Reference: Hanford Waste Vitrification Plant
DOE Contract DE-AC06-86RL10838
Fluor Contract 8457

US DEPARTMENT OF ENERGY
HANFORD WASTE VITRIFICATION PLANT

DESIGN CHANGE NOTICE

DCN - 0060	REV 1	PAGE 1 OF 12
DCN TITLE: TBD/Hold on Canister Storage Tube Length and Tube Base Assembly		DATE INITIATED: 8-27-93
		PACKAGE NO.: E350

1 STANDARD CANISTER STORAGE TUBE ASSEMBLY

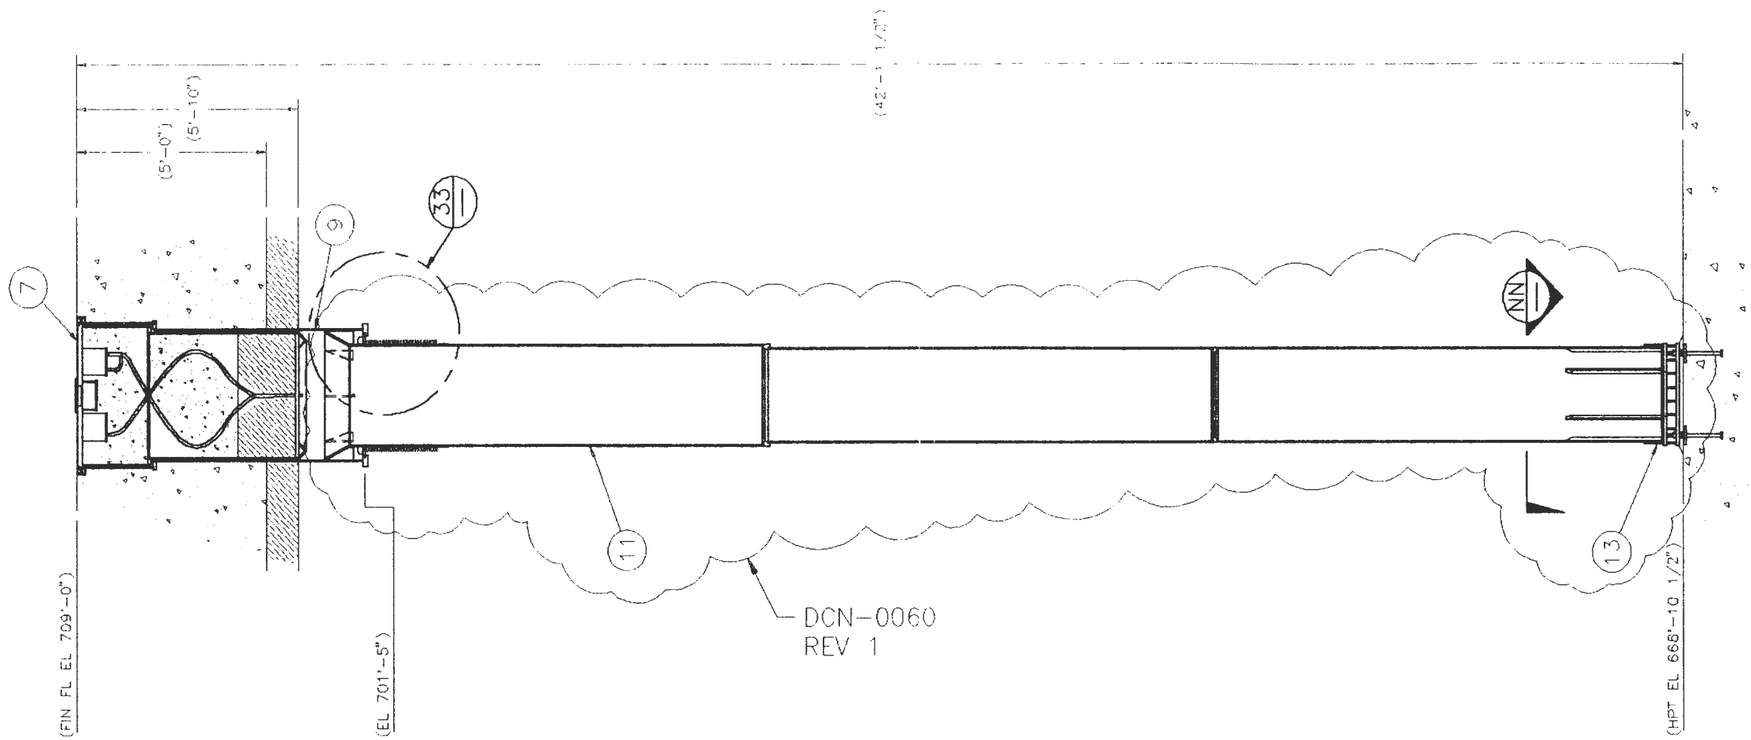
FLUOR DANIEL	U.S. DEPARTMENT OF ENERGY HANFORD WASTE VITRIFICATION PLANT	DESIGN CHANGE NOTICE
DESCRIPTION OF CHANGE: CHANGED STANDARD CANISTER STORAGE TUBE ASSEMBLY		BASE DOC. NO. H-2-120143 SHT/PG. 1 REV. 1 CR NO. N/A DISCIPLINE: MECHANICAL
PREPARED BY:	DATE: 9-14-93	DCN-0060 / REV. 1 / PAGE 7
DISCIPLINE ENGINEER: R. Hulskamp	DATE: 9-16-93

2 OVERPACK CANISTER STORAGE TUBE ASSEMBLY

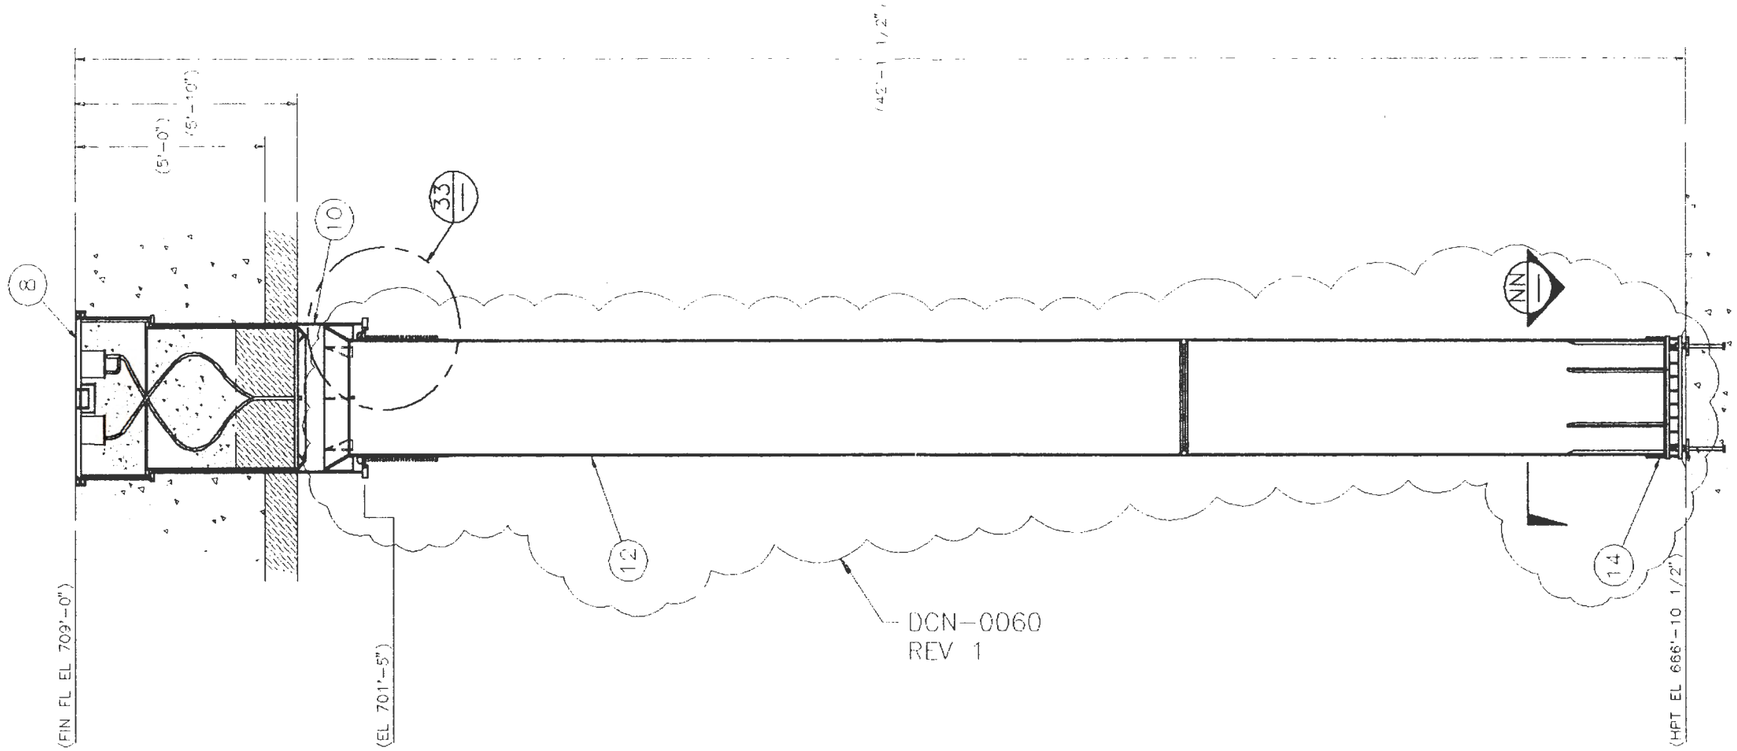
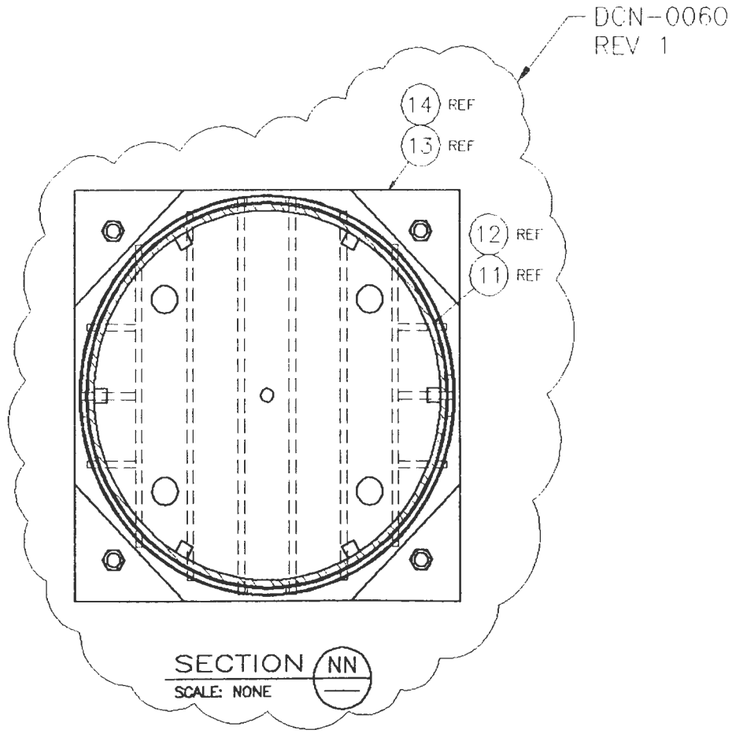
FLUOR DANIEL — U.S. DEPARTMENT OF ENERGY, HANFORD WASTE VITRIFICATION PLANT		DESIGN CHANGE NOTICE
DESCRIPTION OF CHANGE: CHANGE OVERPACK CANISTER STORAGE TUBE ASSEMBLY		BASE DOC. NO. H-2-120143; SHT/PG. 1; REV. 1; CR NO. N/A; DISCIPLINE: MECHANICAL
PREPARED BY:	DATE: 9-14-93	DCN-0060 — REV. 1 — PAGE 8
DISCIPLINE ENGINEER: R. Hulskamp	DATE: 9-16-93

DETAIL 34

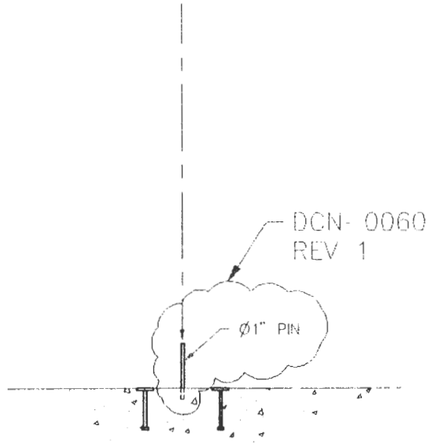
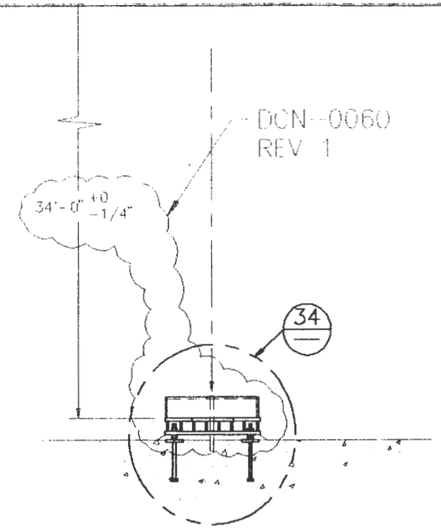
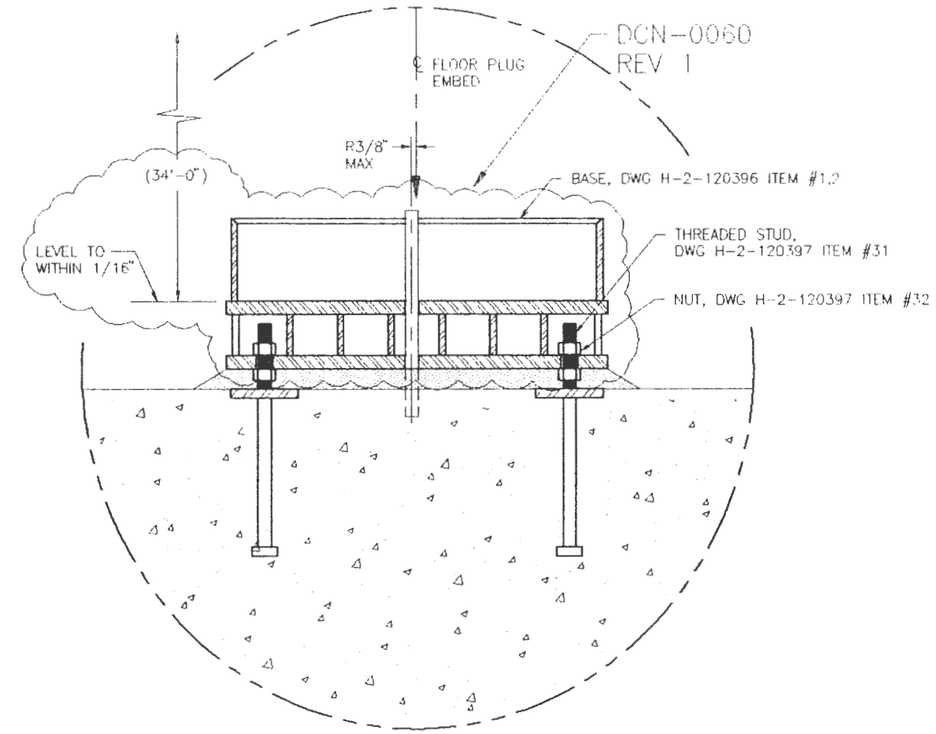
FLUOR DANIEL — U.S. DEPARTMENT OF ENERGY, HANFORD WASTE VITRIFICATION PLANT		DESIGN CHANGE NOTICE
DESCRIPTION OF CHANGE: CHANGE TUBE BASE ASSEMBLY AND INSTALLATION PROCEDURE		BASE DOC. NO. H-2-120143; SHT/PG. 2; REV. 1; CP NO. N/A; DISCIPLINE: MECHANICAL
PREPARED BY:	DATE: 9-14-93	DCN-0060 — REV. 1 — PAGE 9
DISCIPLINE ENGINEER: R. Hulskamp	DATE: 9-14-93

1. REMOVE BRACE.
2. REMOVE BOTTOM PROTECTIVE COVER.
3. INSTALL LOCATING FIXTURE.
4. LOCATE PLUG EMBED CENTERLINE ON VAULT FLOOR.
5. DRILL Ø1" HOLE TO A MAX DEPTH OF 2".
6. INSTALL Ø1" PIN.

1. LOCATE TUBE BASE ASSEMBLY OVER Ø1" PIN.
2. LOCATE THE (4) TUBE BASE ASSEMBLY ANCHOR HOLE CENTERLINES TO THE FLOOR EMBEDS.
3. INSTALL THREADED WELD STUDS TO THE VAULT EMBEDS.
4. PLACE TUBE BASE ASSEMBLY ONTO THE THREADED WELD STUDS WITH THE AIR SLOTS FACING EAST TO WEST.
5. ADJUST THE TUBE BASE ASSEMBLY HEIGHT LEVEL AND LOCK IN PLACE.
6. REMOVE Ø1" LOCATING PIN.
7. CHECK TUBE BASE ASSEMBLY LOCATION TO FLOOR PLUG EMBED CENTERLINE.
8. INSTALL GROUTING FORM.
9. GROUT TUBE BASE ASSEMBLY AS SHOWN.
10. AFTER CURING REMOVE FORMS.
11. REMOVE LOCATING FIXTURE.

STEP 3

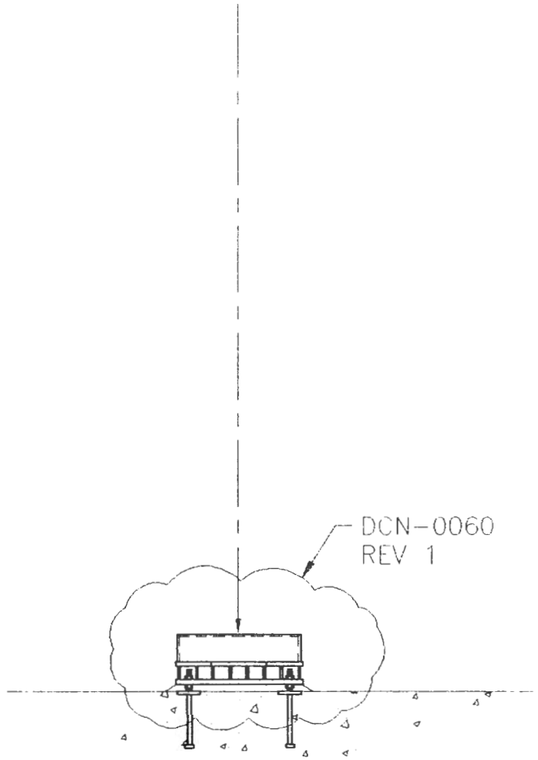
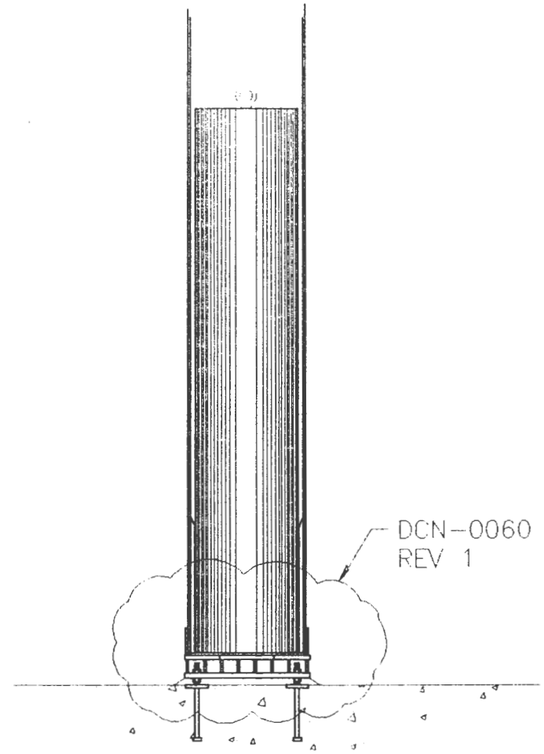
FLUOR DANIEL	U.S. DEPARTMENT OF ENERGY HANFORD WASTE VITRIFICATION PLANT	DESIGN CHANGE NOTICE
DESCRIPTION OF CHANGE: CHANGE TUBE BASE ASSEMBLY		BASE DOC. NO. H-2-120143 SHT/PG. 3 REV. 1 CR NO. N/A DISCIPLINE: MECHANICAL
PREPARED BY:	DATE: 9-14-93	DCN-0060 REV. 1 PAGE 10
DISCIPLINE ENGINEER: R. Hulskamp	DATE: 9-16-93

1. LOWER STORAGE TUBE ASSEMBLY INSIDE THE FLOOR PLUG EMBED.
2. STOP LOWERING WHEN BELLOWS ARE 24" TO 36" ABOVE EMBED C-BORE AS SHOWN. SEE DETAIL-35.
3. INSTALL THE TUBE GUIDES AND CENTER THE TUBE ASSEMBLY. SEE DETAIL-35.
4. CONTINUE TO LOWER THE STORAGE TUBE ASSEMBLY TO THE BOTTOM.
5. REMOVE LIFTING DEVICE.

1. INSERT TUBE GAUGE ASSEMBLY TO THE BOTTOM OF THE TUBE ASSEMBLY. REMOVE TUBE GAUGE ASSEMBLY.
2. INSERT THE CORRECT IMPACT ABSORBER GAUGE TO THEIR MATCHING SEAT AS SHOWN. REMOVE IMPACT ABSORBER GAUGES.
3. IF ALL THE GAUGES CAN BE INSTALLED AND REMOVED WITHOUT ANY BINDING OR INTERFERENCE REMOVE TUBE GUIDES AND CONTINUE TO STEP 5.
